ROCKY MOUNTAIN ARSENAL

Comme
PHASE I FINAL
CONTAMINATION ASSESSMENT REPORT
SECTION 22 - NONSOURCE AREA
(Version 3.1)

FINAL RESPONSE TO
SPECIFIC COMMENTS OF
SHELL OIL COMPANY ON THE
TASK 14 DRAFT FINAL PHASE I REPORT
SECTION 22 - NONSOURCE AREA

FINAL RESPONSES TO GENERAL COMMENTS OF
U.S. ENVIRONMENTAL PROTECTION AGENCY ON
TASK 14 DRAFT FINAL PHASE I REPORT
SECTION 22 - NONSOURCE AREA

Figure 22-UNC-4
PHASE I INVESTIGATION
BORING LOCATION MAP
SECTION 22-UNC
SOURCE: ESE, 1987

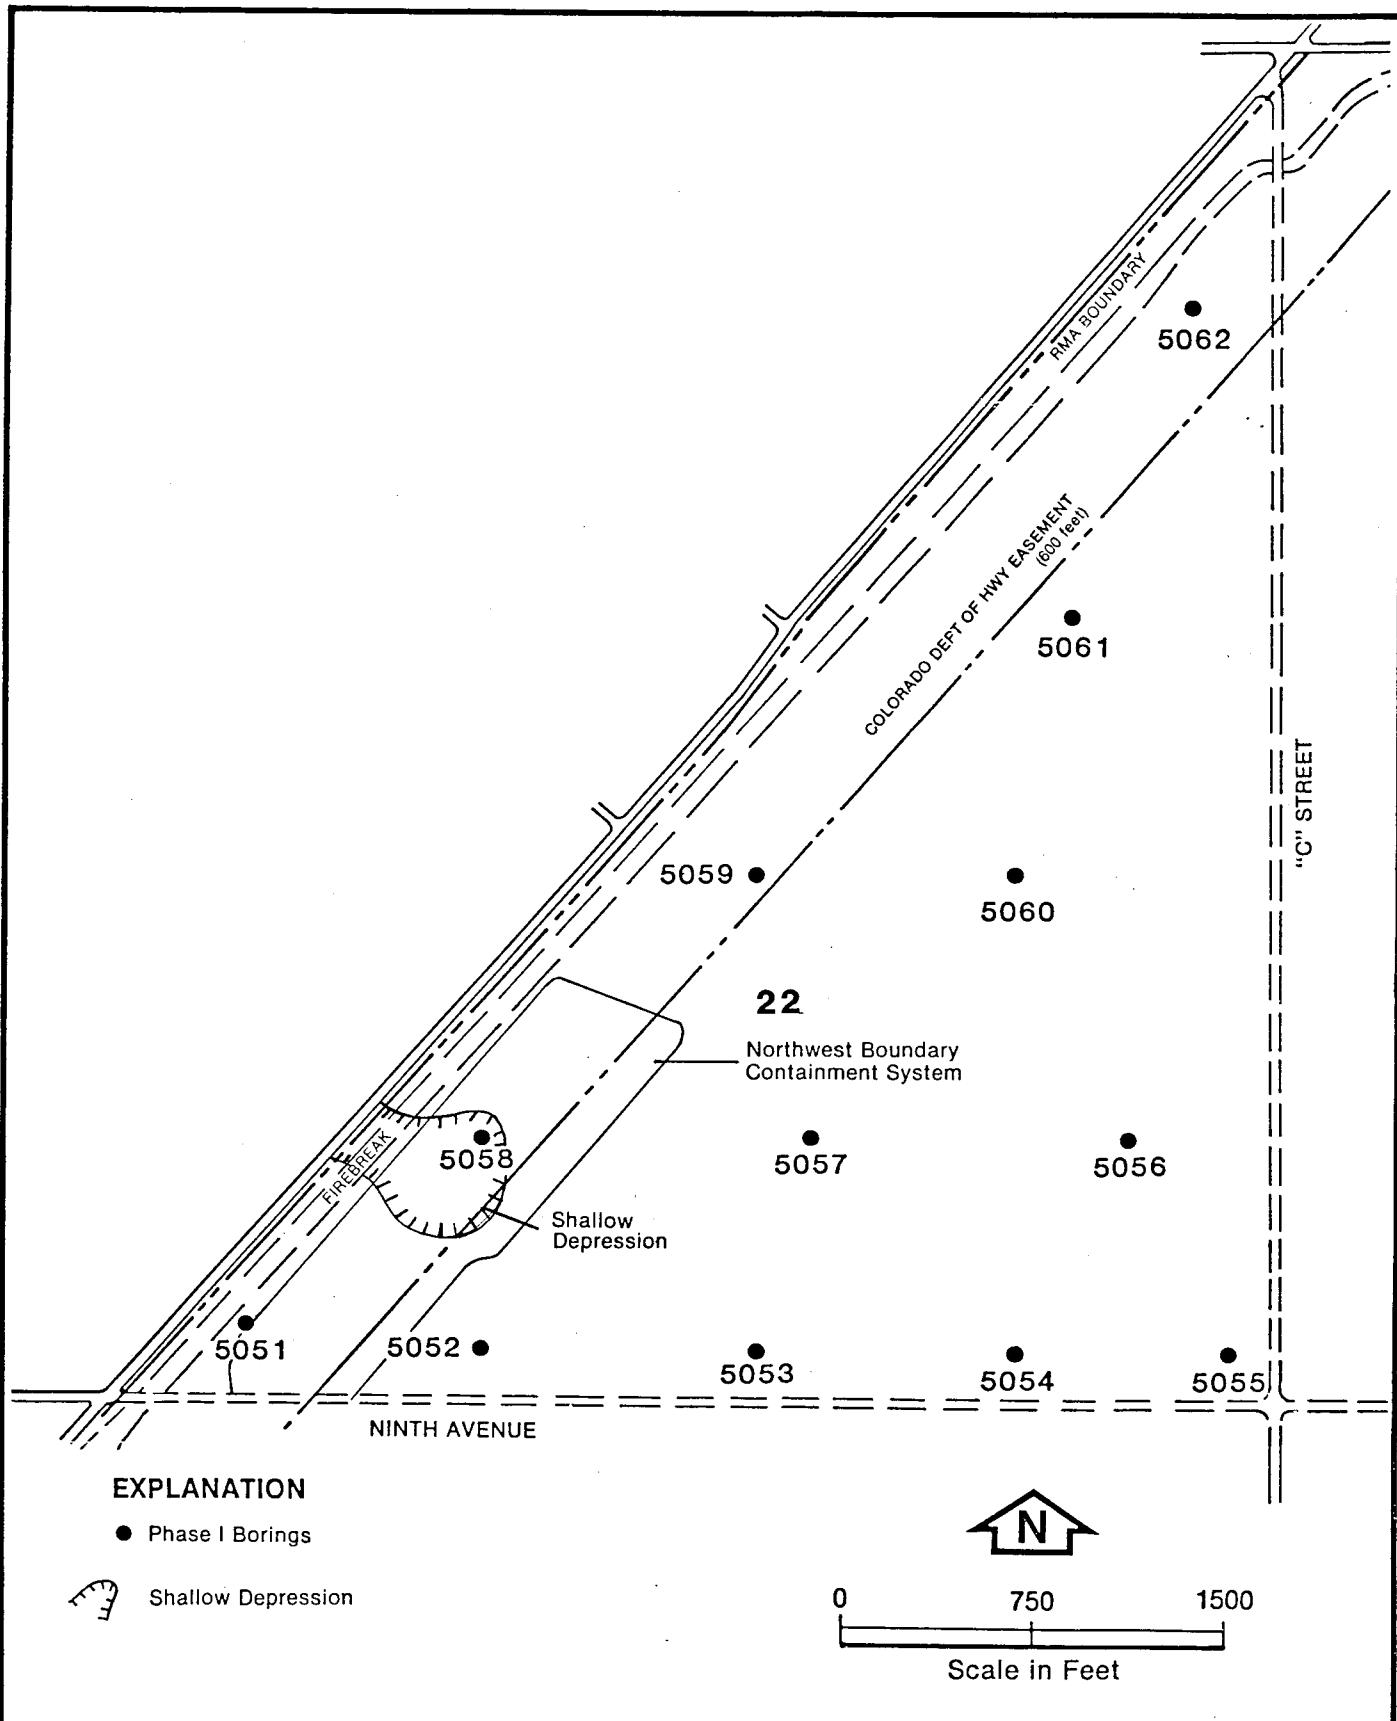
It is recommended that an additional boring be placed in the topographic depression adjacent to the center of the NWBCS.

Boring 5058 was drilled in this natural depression. Target compound concentrations were not above the indicator range and only one nontarget compounds, an unknown hydrocarbon, was found.
